ADDENDUM NO. 1

**INTERMOUNTAIN LAKE PARK NORTH LEVEL 1
REMODEL**

ADDENDUM NO. 2

Purpose for the Addendum: These changes resulted from design team clarifications and city plan review comments.

1 PLUMBING ENLARGED RESTROOM PLAN
PP401 | SCALE: 1/2" = 1'-0"

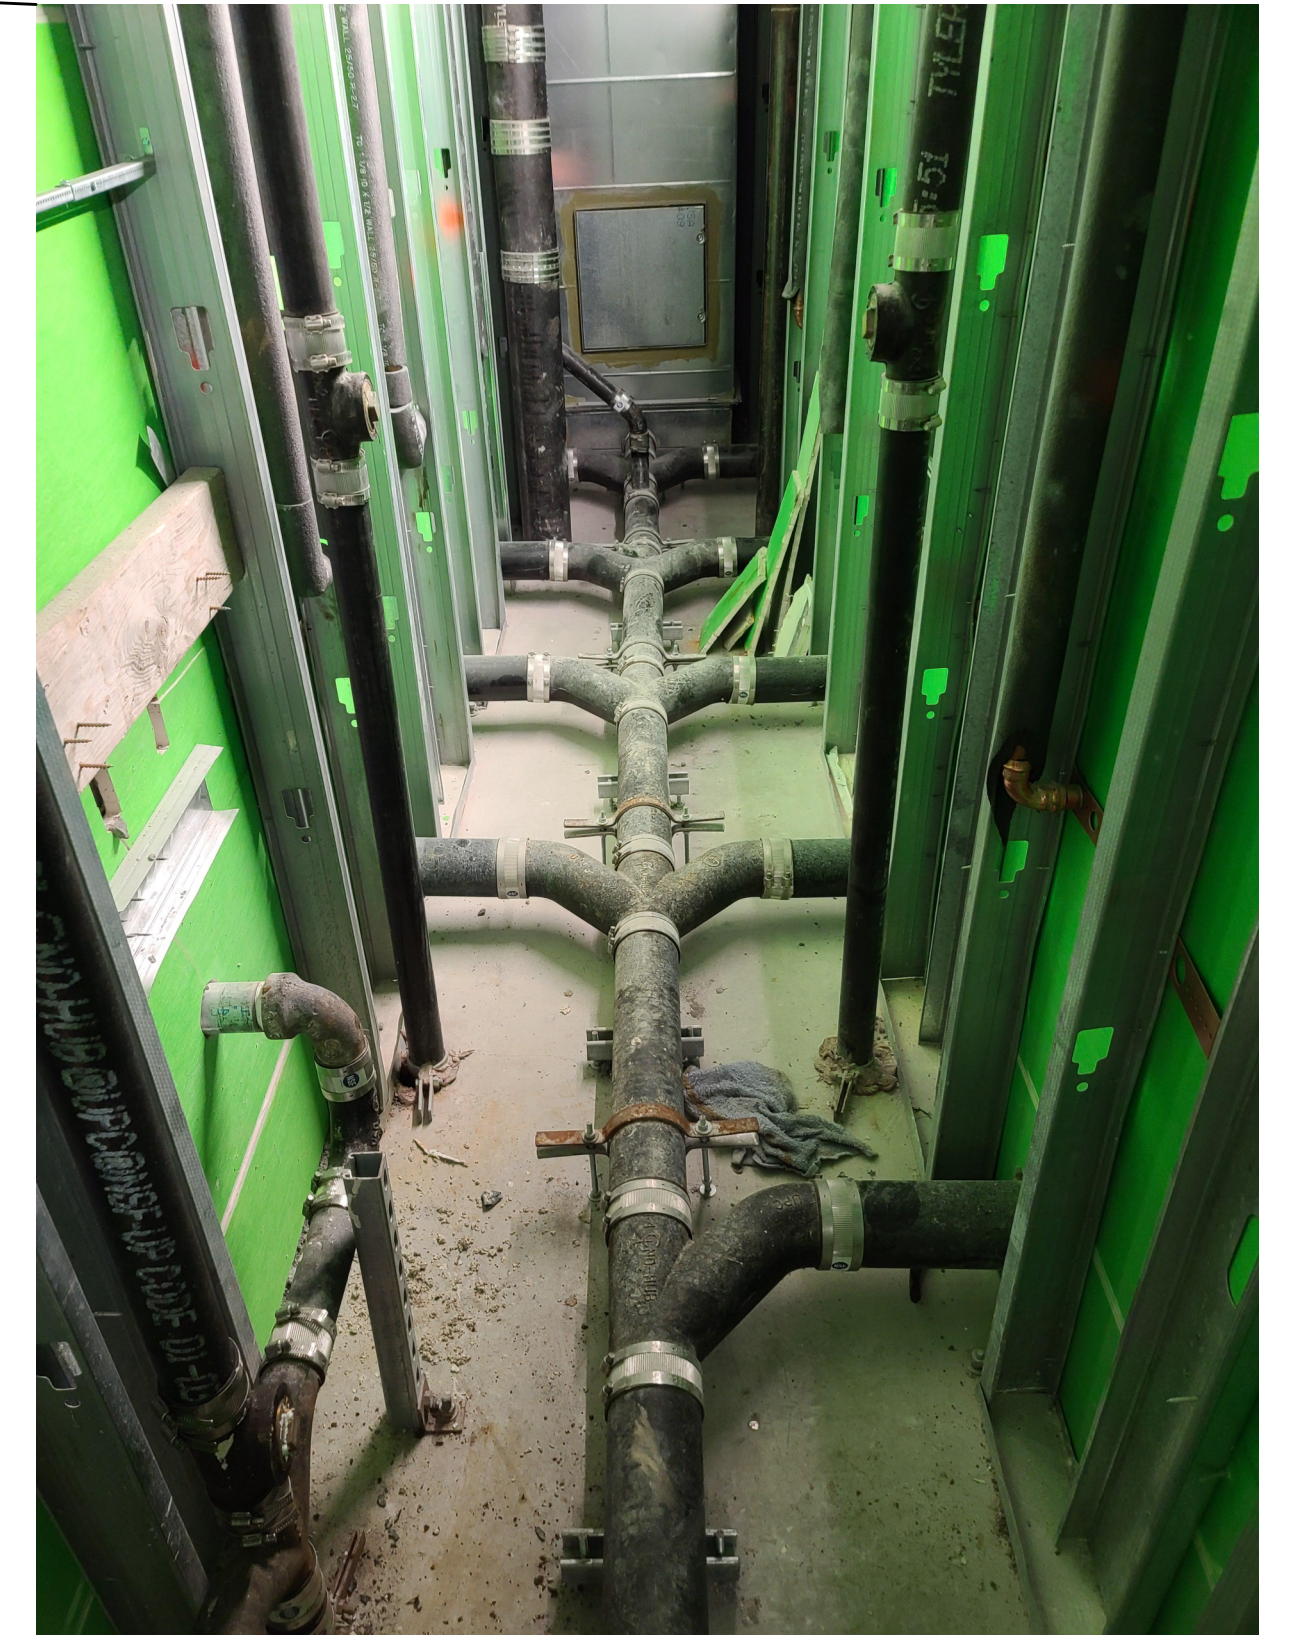
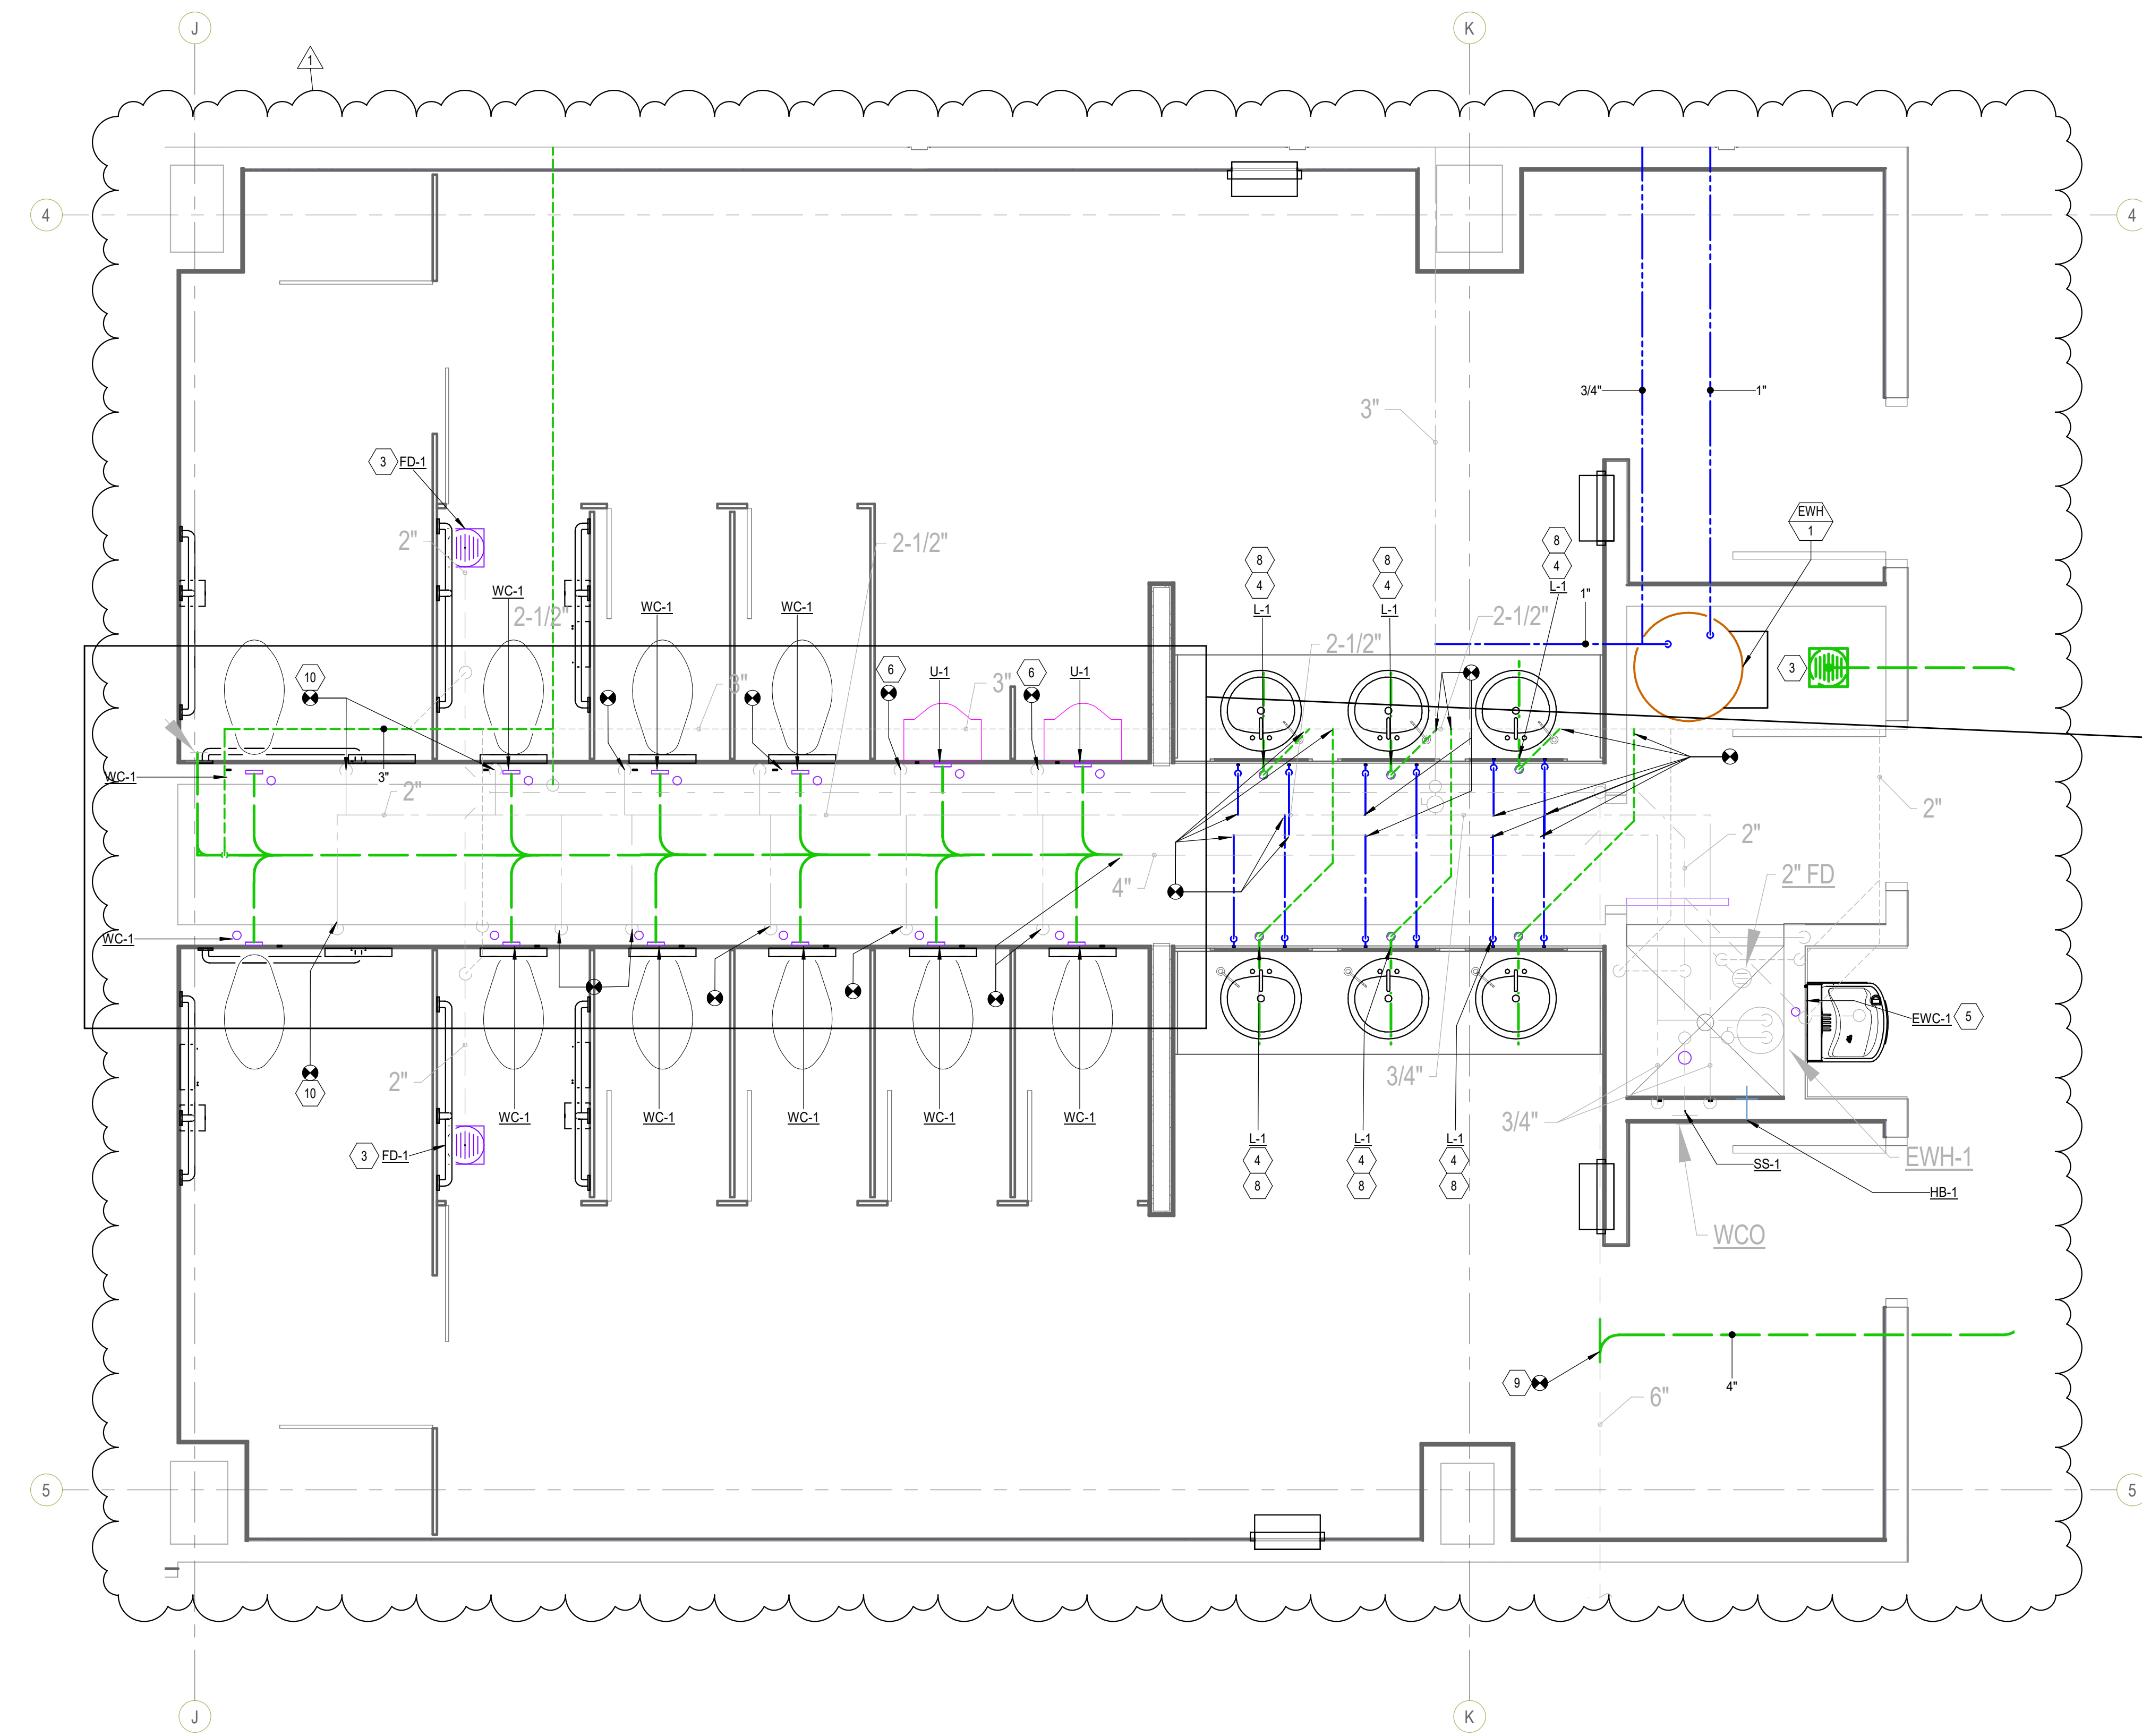
Sheet: PP401 - PLUMBING ENLARGED RESTROOM PLAN

- Pipes colored at the request of the sewer district.

D1 POWER PLAN - LEVEL 1
SCALE: 1/8" = 1'-0"

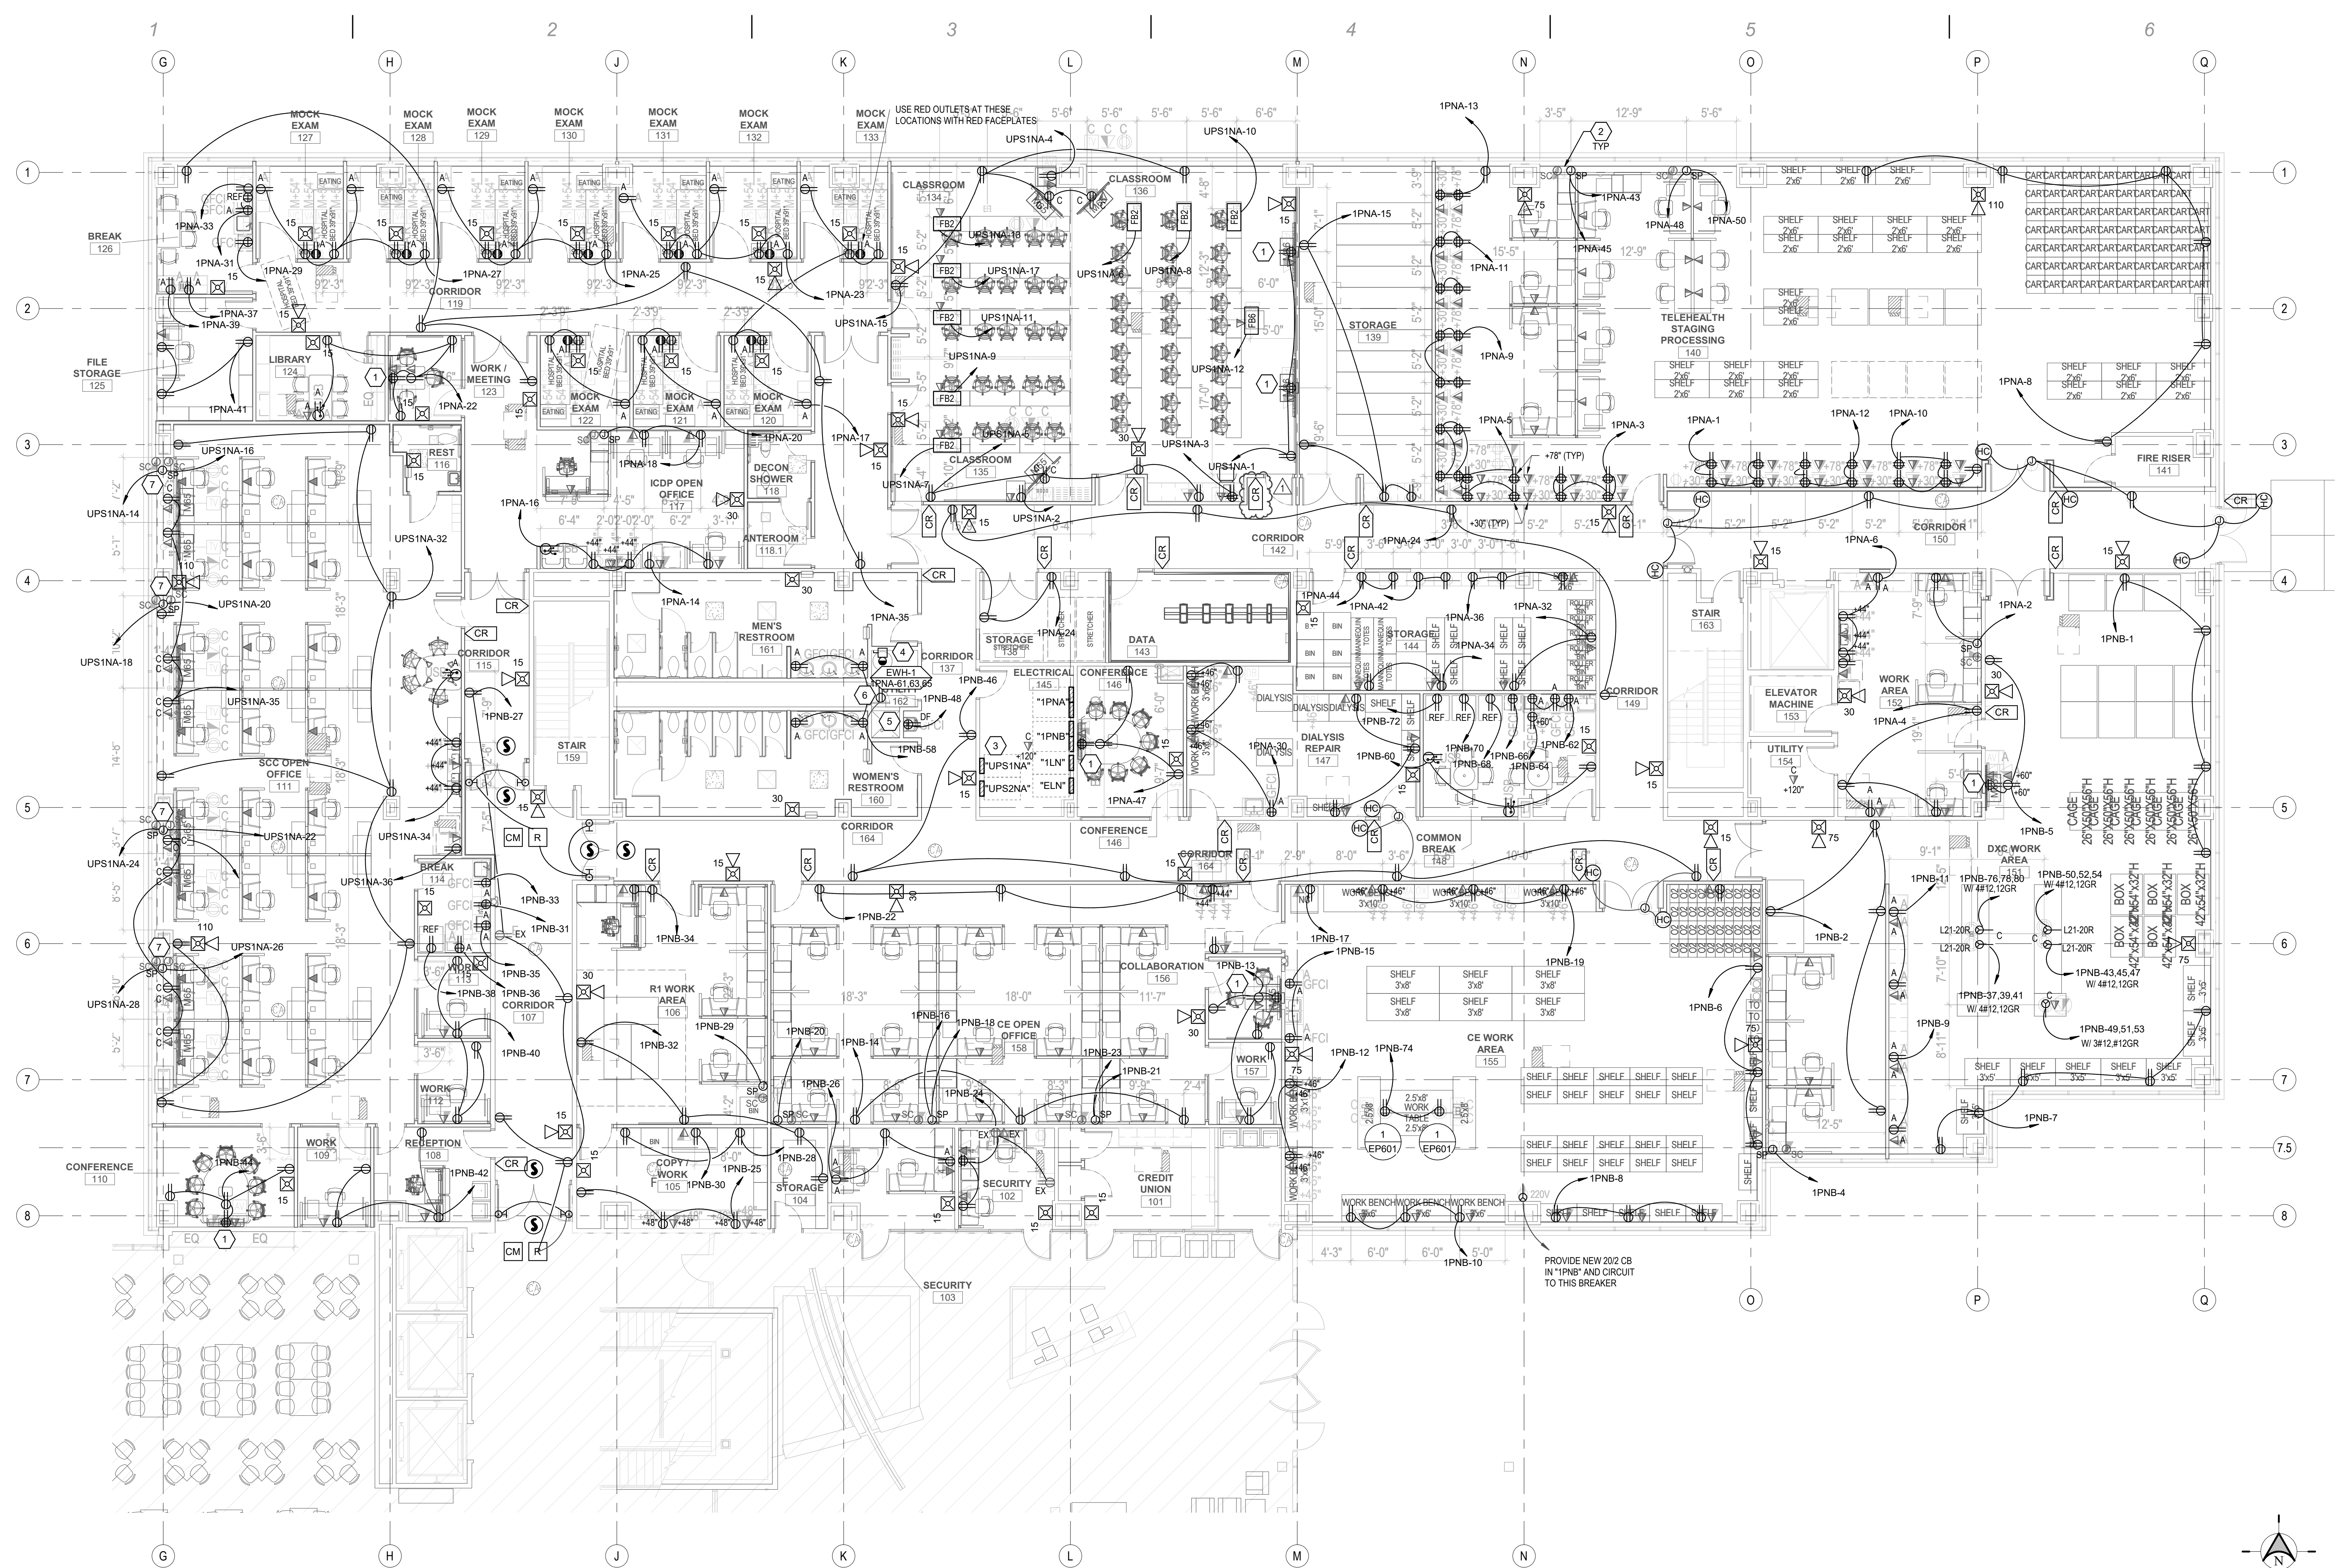
1. Some of the hardware will be provided and installed by the Owner's Access Control Company (Accent Automatics). Hardware sets have been modified to clarify scope. Other door modifications have been made as well. Please have bidders review all hardware sets. **See the revised spec section 08 7100 (hardware sets only), and the revised A601, AP101, and EP101.**
